**From:** Habib, Donald  
**Sent:** Tuesday, July 03, 2012 5:00 PM  
**To:** Snyder, Amy  
**Subject:** Public Documents for Levy 7/5 Public Call (1 of 3)  
**Attachments:** FSAR Section 2.5.4 Text and Figure Revisions - Grouting ML12184A141.pdf; Levy Ltr 108 Response for FukuRecom9.3 6-21-12 ML12173A286.pdf; CEUS SSC Evaluation Process - Option A 07 02 12 ML12185A116.pdf; NRC Letter 108 RAI L-0998 Response - Draft 07-02-12\_Part3 ML12185A109.pdf; NRC Letter 108 RAI L-0998 Response - Draft 07-02-12\_Part1 ML12185A071.pdf

#### 2.5.4.5.1.2 Permeation Grouting

# OPTION A: EVALUATION OF CEUS SSC SEISMIC HAZARDS AT LNP SITE

## Revised FSAR Figures

**Revised Figure 2.5.2-294:** Horizontal 10<sup>-5</sup> UHRS, GMRS, and Scaled GMRS Based on CAV for the LNP Site.

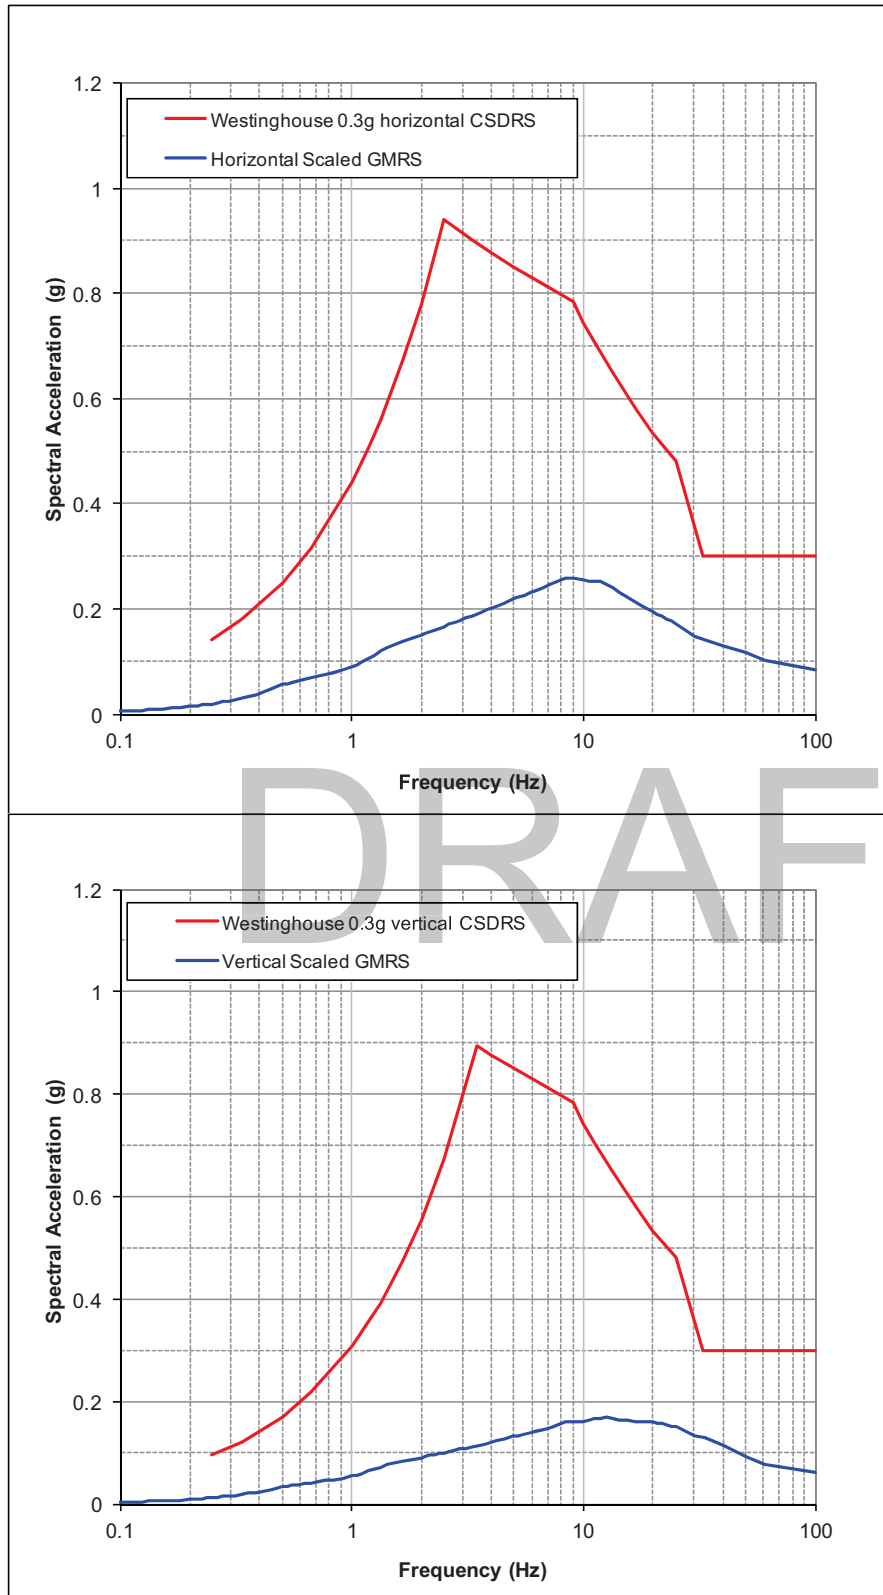
Regulatory Guide 1.208 also specifies that when the value of  $A_R$  exceeds 4.2, the amplitude of the GMRS is to be no less than  $0.45 \times SA(0.1H_D)$  that is, 45 percent of the  $10^{-5}$  UHRS. As the  $10^{-4}$  UHRS with CAV is 0, this second criteria is used to define the horizontal GMRS. Figure 2.5.2-294 shows the horizontal GMRS calculated as  $0.45 \times SA(0.1H_D)$ .

The [scaled](#) horizontal and vertical GMRS are compared to the Westinghouse Certified Seismic Design Response Spectra (CSDRS) on [Figure 2.5.2-296](#). The site [scaled](#) GMRS are enveloped by the CSDRS.
